**CITY OF WINTER PARK
PLANNING AND ZONING BOARD**

**Staff Report
November 4, 2014**

REQUEST OF UNICORP NATIONAL DEVELOPMENT INC. FOR: AN ORDINANCE AMENDING THE "COMPREHENSIVE PLAN" AND THE FUTURE LAND USE MAP SO AS CHANGE THE FUTURE LAND USE MAP DESIGNATION OF COMMERCIAL TO MEDIUM DENSITY PLANNED DEVELOPMENT (PD-1) ON THE PROPERTY AT 110 S. ORLANDO AVENUE.

REQUEST OF UNICORP NATIONAL DEVELOPMENT INC. FOR: CONDITIONAL USE APPROVAL TO REDEVELOP THE PROPERTY LOCATED AT 110 S. ORLANDO AVENUE INTO 31,960 SQUARE FEET OF RETAIL/RESTAURANT GROUND FLOOR DEVELOPMENT WITH 53 MULTI-FAMILY UNITS LOCATED ON THE SECOND THROUGH FOURTH STORIES OF THE PROJECT FOR A TOTAL MAXIMUM SQUARE FOOTAGE OF 232,570 FEET .

Setback Diagram

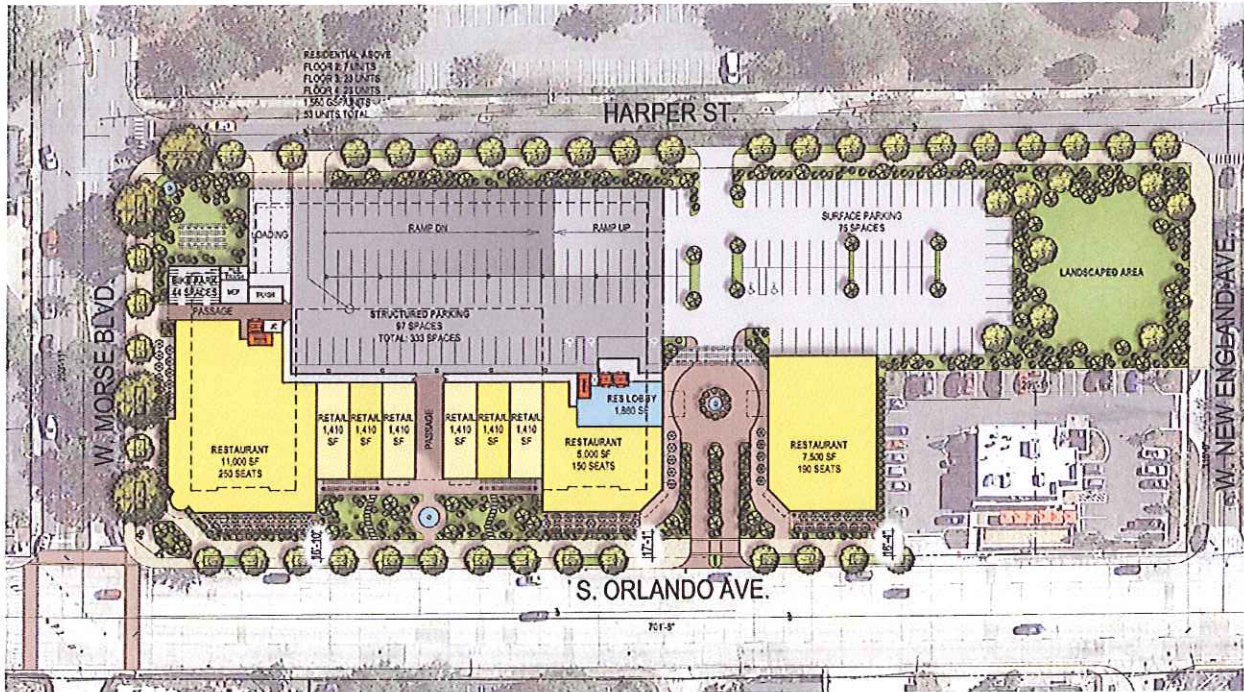
The developer is asking for two variances from the rear setback requirements of 20' for the first and second stories and 25' for the third and fourth stories. The developer is requesting a 10' variance on the first and second stories facing Harper Street, making the setback 10' instead of the required 20'. He is also requesting a 5' variance for the 3rd and 4th stories facing Harper Street.

Fisrt Floor Site Plan

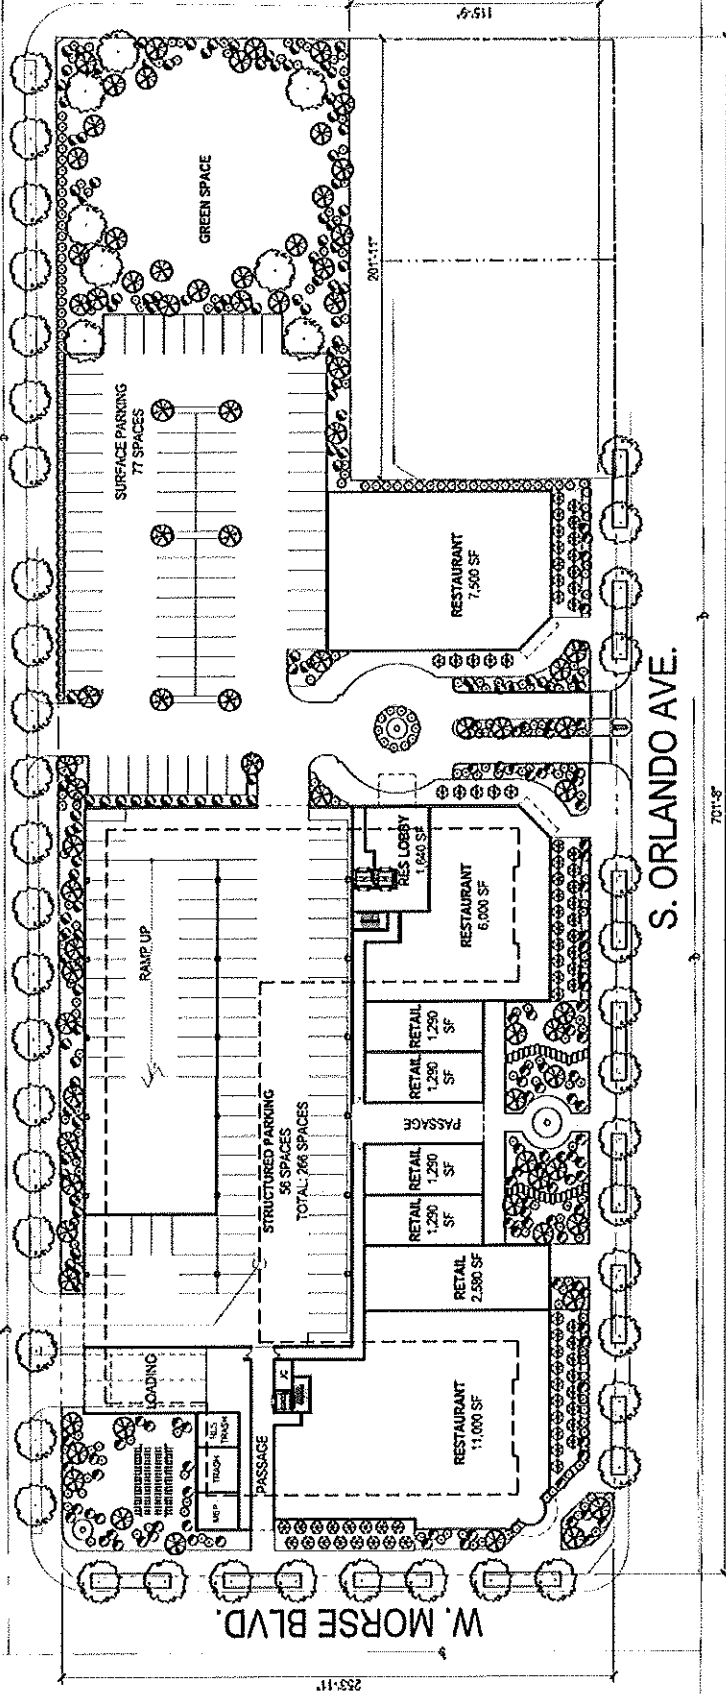
A revised Traffic Impact Analysis with the corrected HCS analysis should also be required. The analysis should also include changes to the trip distribution if the right-in/right-out configuration is used for the main driveway. Let me know if you have any questions.
